Decisions Report: 50% detailed design

Refresh Vacluse and Diamond Bay Project

1 - GROUND SURFACES

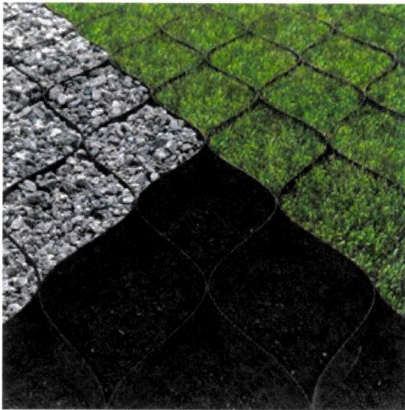
GRASS, I do not see a reason why the surface cannot be naturally packed down enough and stabilised to support the maintenance trucks. This is not a high traffic zone. Each time a visit is done, if there is damage that will be an easy fix to get the grass growing again. For example, mesh like blocks that could sit on top of the packed surface/grass. something like the [options here](#)

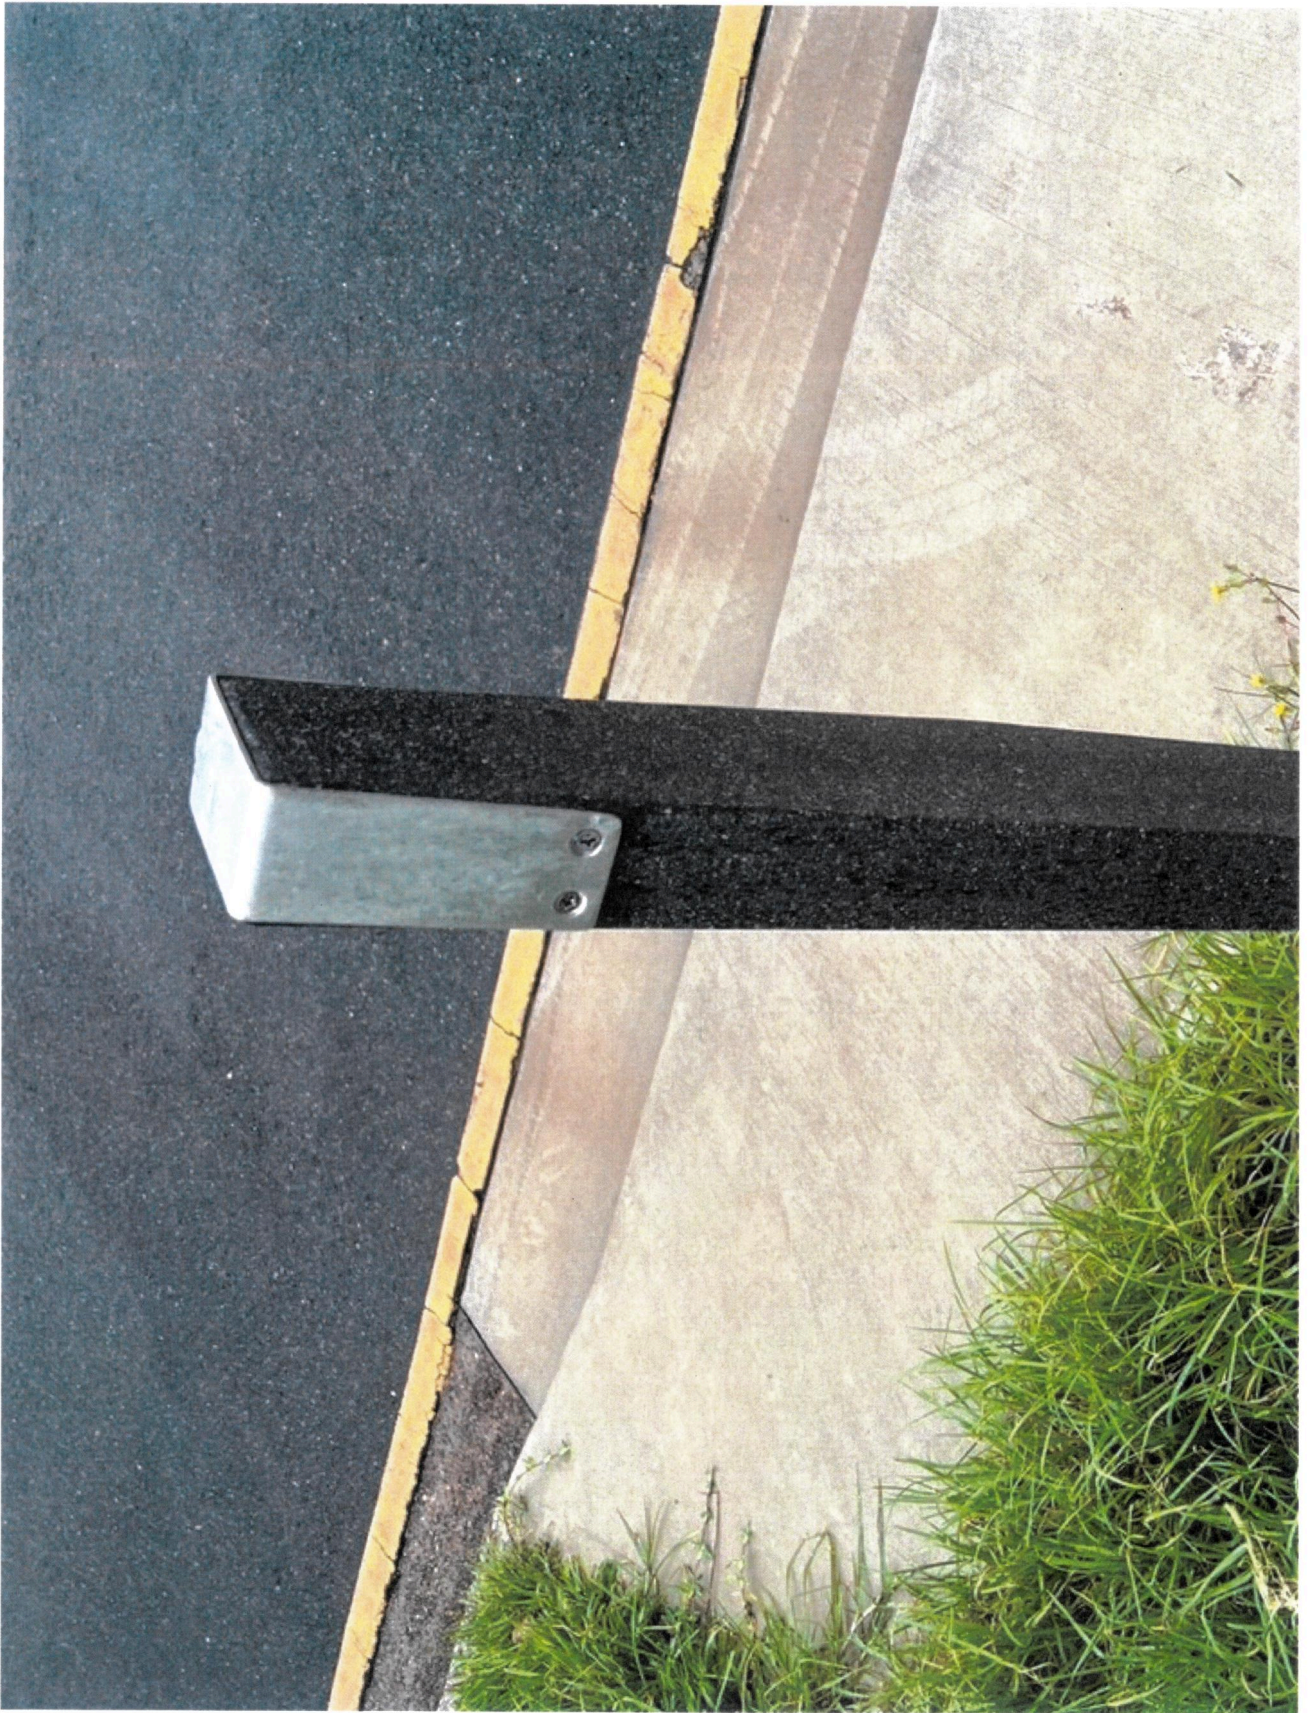
6 - LANDSCAPING - Due to the issues we already have with the Cliff Walk and Biodiveristy Action Plan proposed plantings I DO NOT want ANY addtional planting as part of this project other than grass as part of the **VEVOR Geo Grid**

7 - COLORS - Equipment boxes should be GREEN to blend into the grass of the reserve. Any materials that will be visible should be green. NO YELLOW SHOULD BE USED ANYWHERE. Hidden Pull Up Bollards can be stainless steel color but MUST BE 2205 grade or above

8 - COASTAL FENCE - The design of the coastal fence has been dicated by Waverely Council. However the materials used are NOT. ONLY 2205 Stainless Steel should be used in the section of the Coastal Fence which is part of this project. The wood panel infill in the Waverely Coatal Fence should be made of composite wood in a brown color. Real wood should NOT be used as it will quickly disintegrate in the elements

9 - BOLLARDS between Eastern Ave and the Reserve. See attached photo or look at Bulga Road. The composite grey bollards on a concrete footing which have a lock and go flat are perfectly suited to this environment and are aready shown to be appropriated at Bulga Road
